SCHWEIZER SERVICE BULLETIN

B-236
4 Sep 1991

SUBJECT: INSPECTION OF LOW TIP SPEED TAIL ROTOR SWASHPLATE BELLCRANK ASSEMBLY HOLE

MODELS AFFECTED: Model 269C Helicopters with Serial Numbers 1291 through 1432, inclusive, EXCEPT 1413 AND 1416

Figure B-236-1. 269A6042 Bellcrank Assembly Segment

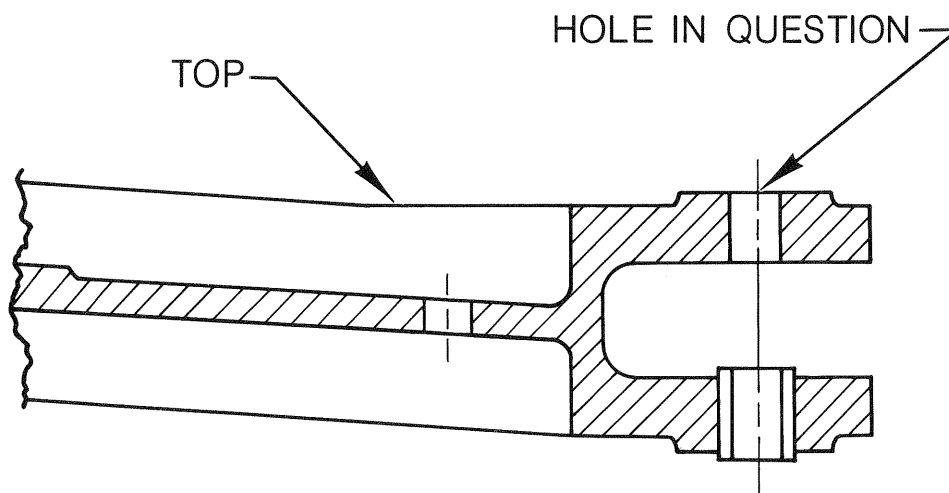
PREFACE: 269A6042 bellcrank assemblies have been manufactured with either a 3/16 (.19) inch or a 1/4 (.25) inch hole through the upper surface on the end which attaches to the tail rotor control rod assembly. Those assemblies manufactured with the 1/4 (.25) inch hole should have an installed bushing which reduces the hole size to 3/16 (.19) inch.

- A possibility exists that some helicopters were manufactured WITHOUT the installed bushing.
- A one-time inspection is required to determine if this hole is:
 - 3/16 (.19) inch (**CORRECT**)
 - 1/4 (.25) inch with installed bushing, 3/16 (.19) inch I.D. (**CORRECT**)
 - or 1/4 (.25) inch WITHOUT installed bushing (**INCORRECT**).
- Failure to comply with the requirements of this Service Bulletin at the time interval specified under TIME OF COMPLIANCE could result in excessive wear of the bellcrank and excessive play in the flight control system.

- a. Remove bolt attaching bellcrank assembly to tail rotor control rod (BHMI, Section 9). Determine assembly upper hole size (Figure B-236-1).
- b. If hole is 3/16 (.19) inch or 1/4 (.25) inch with installed bushing (I.D. 3/16 (.19) inch), reinstall bolt (BHMI, Section 9), ensuring slotted bushing is in place in LOWER hole. Proceed to step d. below.

- c. If hole is 1/4 (.25) inch WITHOUT installed bushing:
- (1) Do NOT rework bellcrank assembly. Return assembly to SAC.
 - (2) Replace bellcrank assembly with serviceable spare and reassemble after inspecting condition of tail rotor control rod (BHMI, Section 9).
 - (3) Contact SAC Product Support Department.
- d. Record compliance with this Service Bulletin in the aircraft records.
